Project	IEEE 802.16 Broadband Wireless Access Working Group < http://ieee802.org/16 >		
Title	[IMT-Advanced Convergence Proposal on OFDM Numerology]		
Date Submitted	[2009-07-06]		
Source(s)	Mary Chion Sean Cai	E-mail:	[mchion@zteusa.com] * http://standards.ieee.org/faqs/affiliationFAQ.html >
	ZTE Corp		
Re:	[Call for comment for AWD, session 62, ballot ID: tgmwrkdoc]		
Abstract	[Provide detailed rationale for proposed for new IEEE802.16m OFDMA numerology.]		
Purpose	[To discuss and accept the proposed solution in this contribution, and adopt the solution text of this contribution into the AWD baseline document 80216m-09_0010r2.doc.]		
Notice	<i>This document does not represent the agreed views of the IEEE 802.16 Working Group or any of its subgroups. It represents only the views of the participants listed in the "Source(s)" field above. It is offered as a basis for discussion. It is not binding on the contributor(s), who reserve(s) the right to add, amend or withdraw material contained herein.</i>

IMT-Advanced Convergence Proposal on OFDM Numerology

Mary Chion Sean Cai
ZTE Corporation

Figure eee Basic frame structure for FDD mode

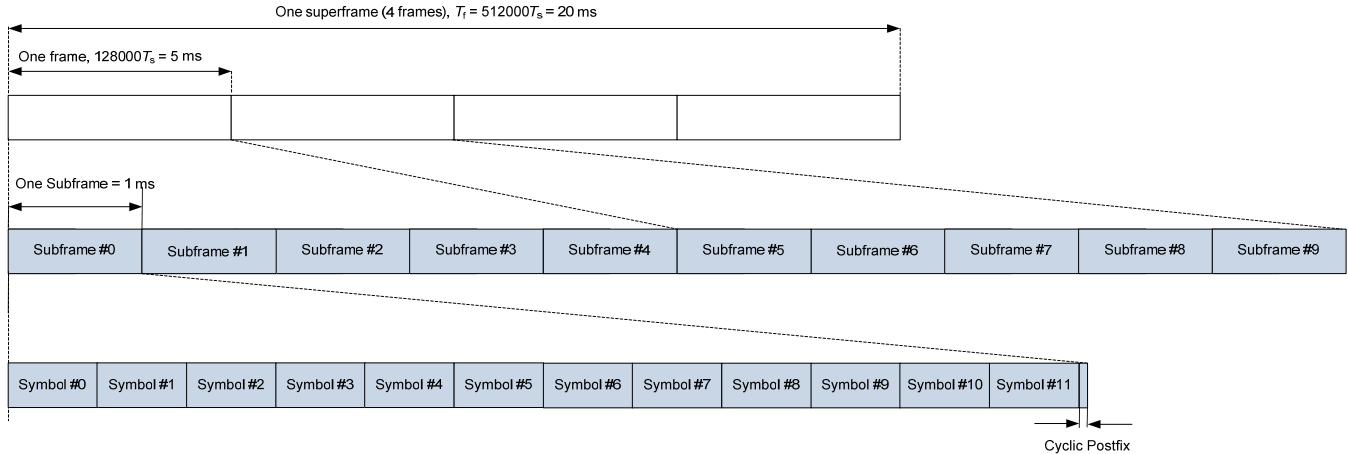
[On page 116, line 26, insert new subclause 15.3.3.1.1 Basic frame structure with fixed subcarrier spacing, and replace it with the following text.]

15.3.3.1.1. Basic Frame structure with fixed subcarrier spacing

The advanced air interface basic frame structure is illustrated in Figure eee for FDD mode and Figure fff for TDD mode. Each 20 ms superframe is divided into four equally-sized 5 ms radio frames. Each 5 ms radio frame further consists five equally-sized 1 ms subframes. According to the different configurations in Table bbb, the number of symbols in a subframe can be different.

Figure fff. Frame Structure Type for TDD mode

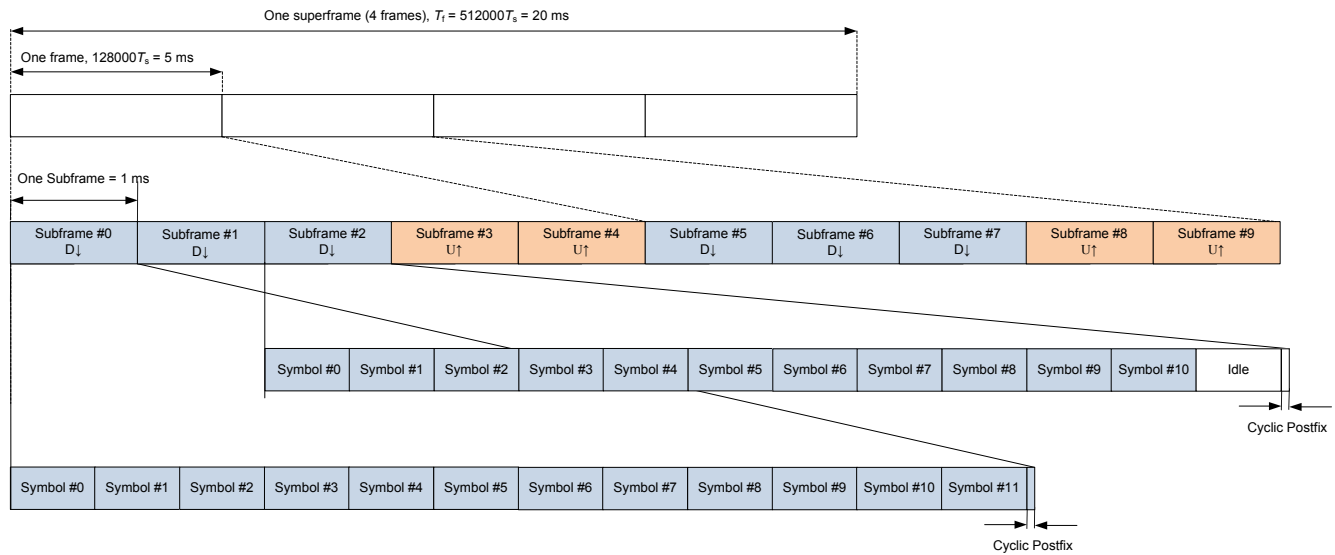
For Type TDD mode, a subframe is also the smallest unit to be configurable for downlink and uplink transmission. As shown in Figure 7, Subframe# 0 is always reserved for downlink transmission. Starting from Subframe# 1, each subframe can be configurable for downlink or uplink transmission. For each subframe in a radio frame, “D” denotes the subframe is reserved for downlink transmission, “U” denotes the subframe is reserved for uplink transmission. The concept of slots is only used to describe the dimensions of resource blocks.

Figure ggg. Superframe & frame configurations with trie data structure

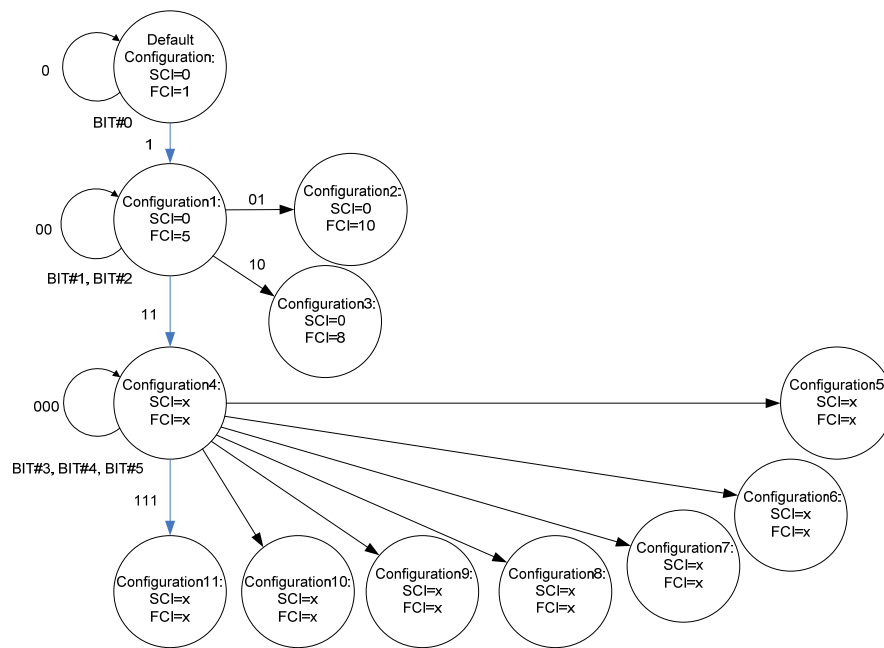
When a network is deployed, a superframe is often configured to a default system profile. However, a superframe can change its frame structure via superframe control signaling. There are many different superframe and frame configurations are available for different networks deployment. However, it is believed that only limited set of configurations are practically used within a particular network. In order to minimize the number of bits for superframe and frame configurations to be transmitted in the air by superframe header the trie data structure is used to broadcast configurations information. If the network is operating in default configuration, only one bit is transmitted in the air to indicate that the superframe and frames are configured in default mode. The example is shown in Table iii; the values of Superframe Configuration Index (SCI) and Frame Configuration Index (FCI) in the Figure ggg are selected for illustration purpose.

Figure iii. Pilot patterns for 1 and 2 data streams

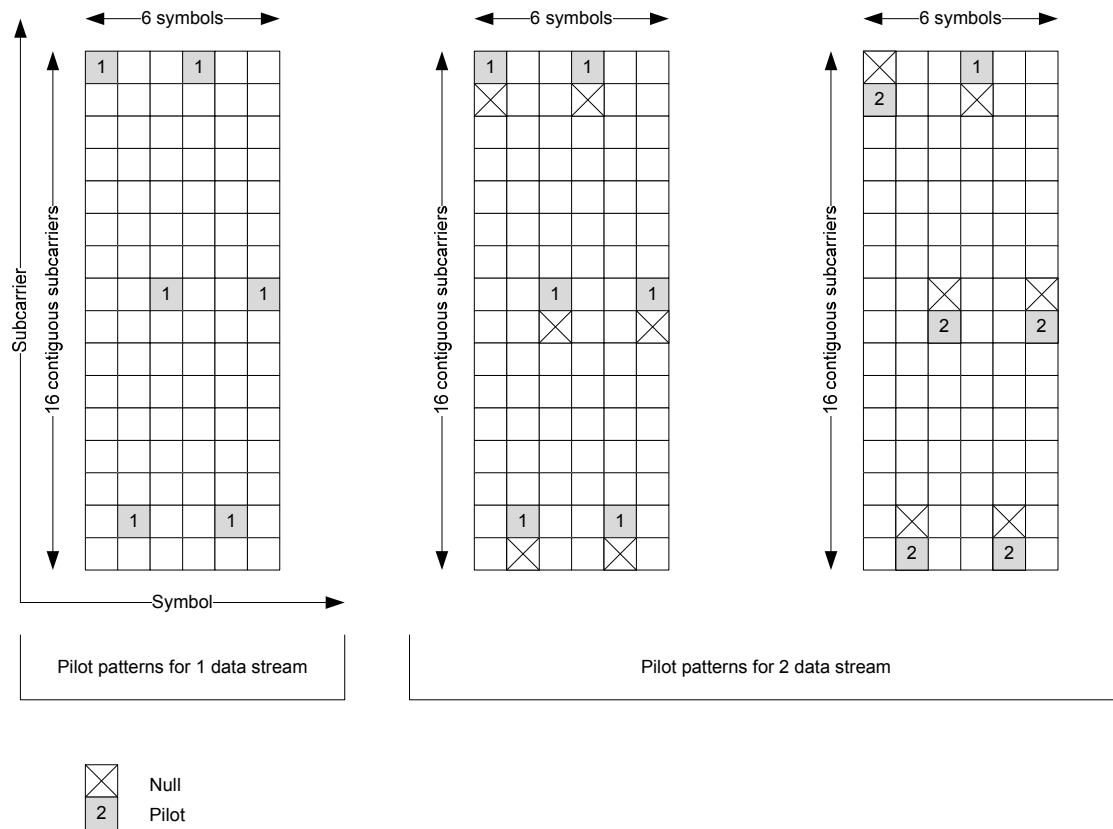
[On page 151, line 45, insert section 15.3.5.4.1.1. as following]

15.3.2.4.1 Pilot patterns for fixed subcarrier spacing

The pilot patterns are specified within a PRU.

For $N_{\text{symb}}=5$, the last symbol of the pilot patterns as shown in Figure iii or Figure jjj is deleted. Similarly for

$N_{\text{symb}}=3$, the last three symbols of the pilot patterns are deleted.

Figure kkk. Pilot patterns for 8 downlink only data streams

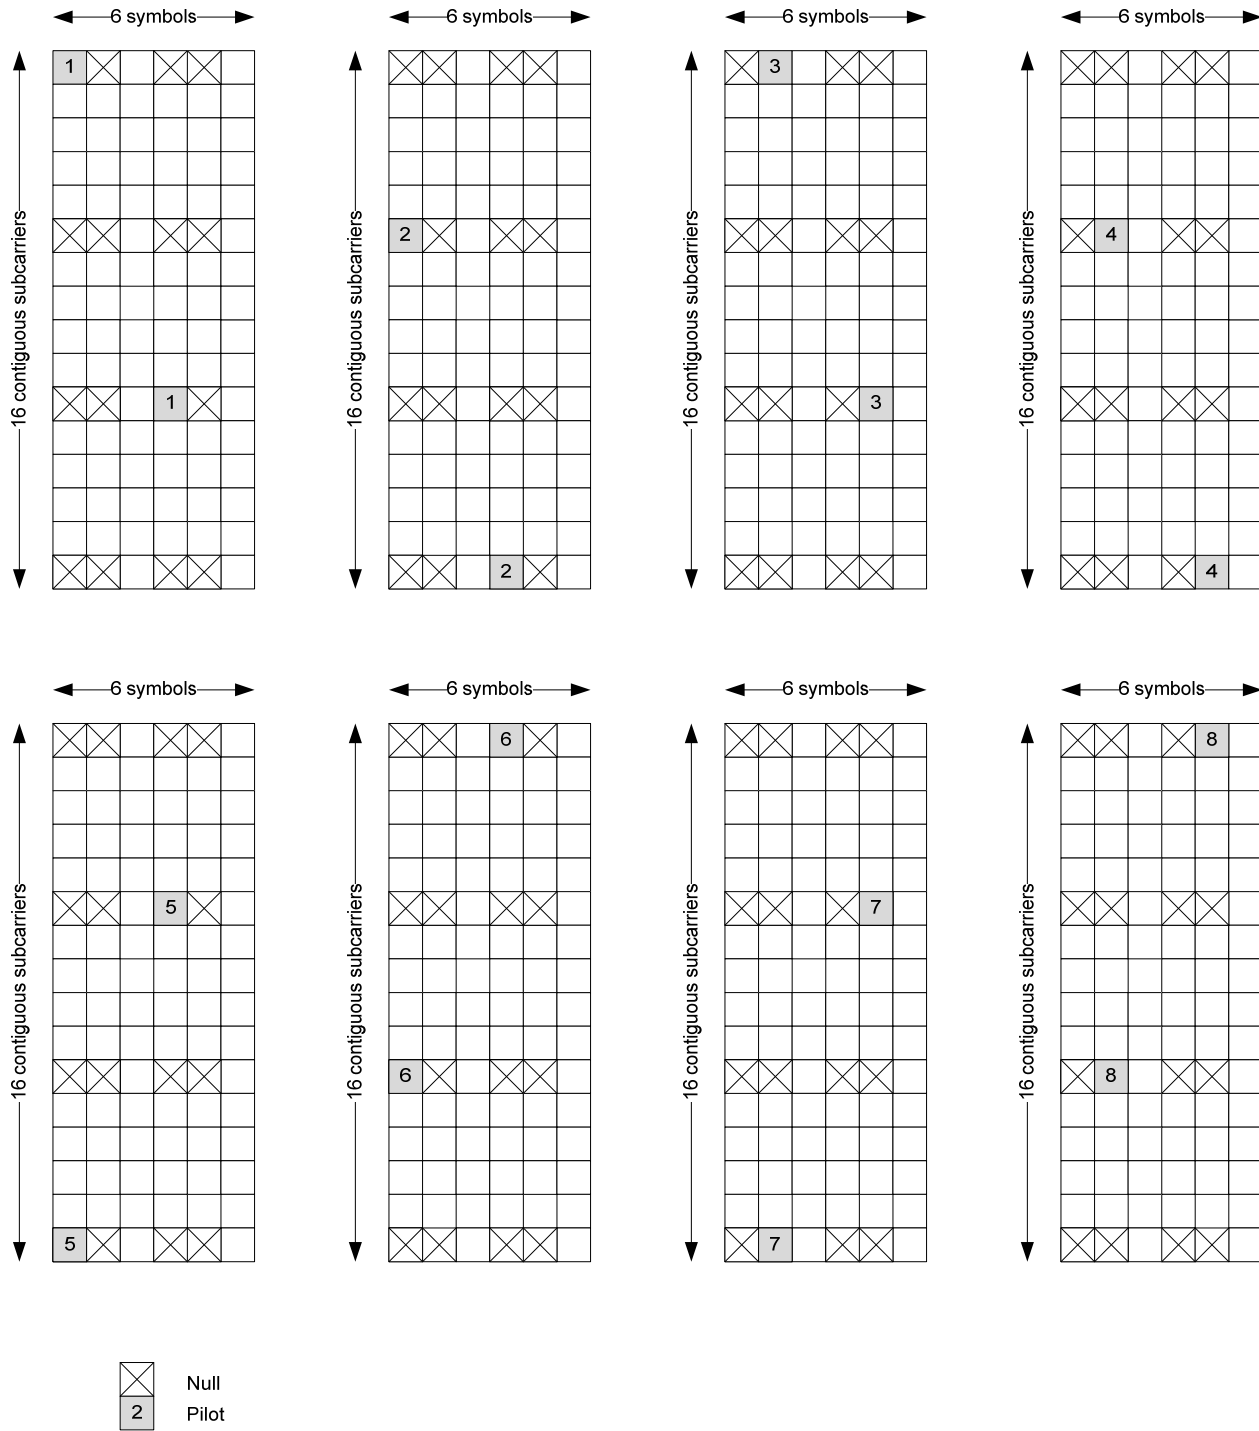
For $N_{\text{symb}}=5$, the last symbol of the pilot patterns as shown in Figure kkk, or Figure III is deleted. Similarly for $N_{\text{symb}}=3$, the last three symbols of the pilot patterns are deleted.
